Your ref: SSD-5544 Modification 7
Our ref: 12640825

Interim Audit Advice 1 – Ampol Kurnell Remedial Action Plan Review

AECOM, 2026. *Kurnell terminal SSD-5544 MOD-7, Appendix E – Remedial Action Plan*, Ref.60695088, Rev.4, 29 January 2026 – (the “RAP”).

ATTACHMENT A - AUDIT COMMENTS REGISTER

Figure 1 Site Audit Boundary (modified from Figure F2 of AECOM, 2026a).

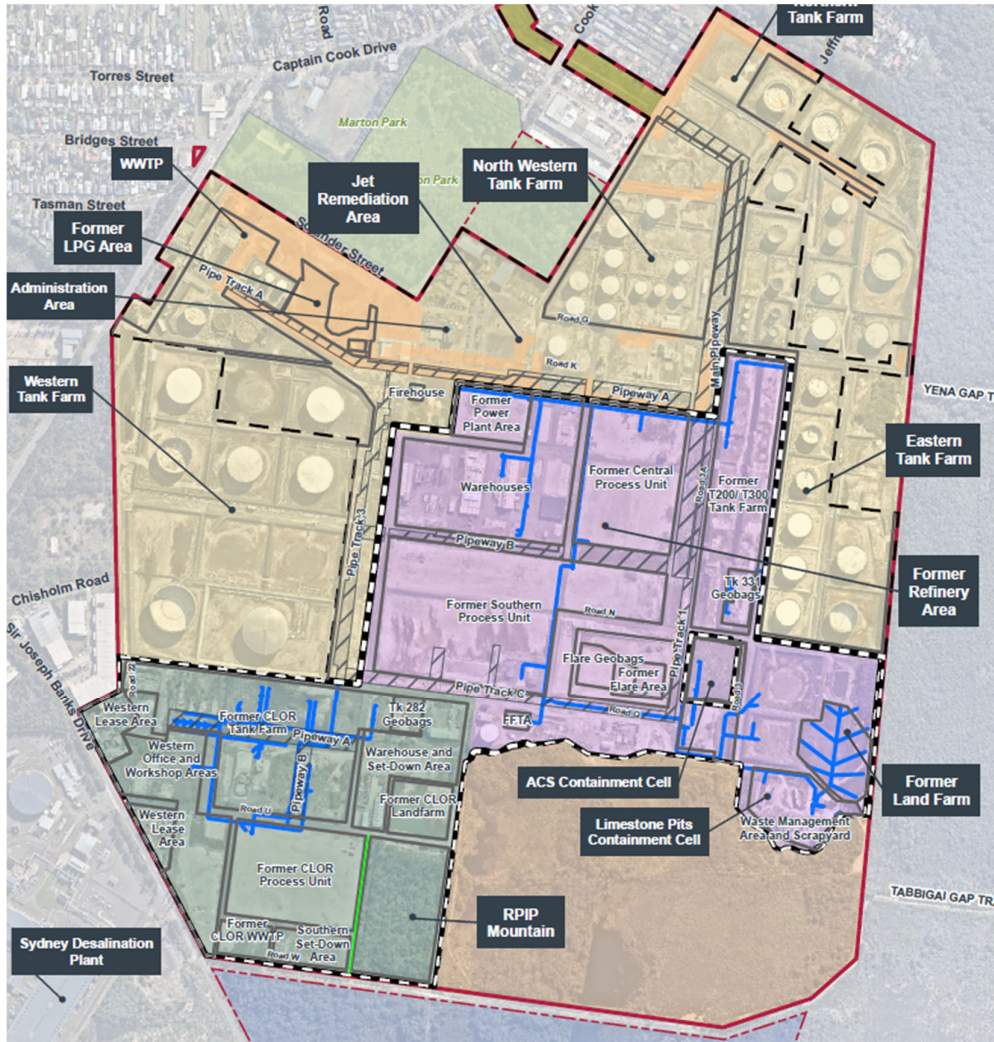
17	2.3 Surrounding Land Use	The following surrounding land uses are missing: Sydney Desalination Plant (SDP), Village of Kurnell, Kurnell Public School, Kurnell Kindergarten, and the small shopping centre. Please include.	Text amended	Comment closed.	-	-
18	Figure 1	It would be helpful to include the audit boundary in Figure 1. If this figure is from another source please reference it.	Figure updated	Comment closed.	-	-
19	2.8 Hydrogeology	The aquifer properties presented in Section 2.8 (Aquifer permeability is ~25 m/day; Advective velocity is ~133 m/year; Aquifer porosity is assumed to be 0.4) of the RAP differ from those included in the Overarching SAQP.	Update with consideration to new data as presented in SAQP	Comment closed.	-	-
20	3.1 Site History	The following have not been discussed in the SAQP; please include the source: "Establishment of large bunds to separate the refinery from the surrounding landscape, with a significant portion of the sand for this sourced from dredging in Botany Bay."	Explicit reference not found. Note removed. It is recognised that Kurnell was a significant source of sand (through sand mining) for construction from the 1930s.	Noted. Comment closed.	-	-
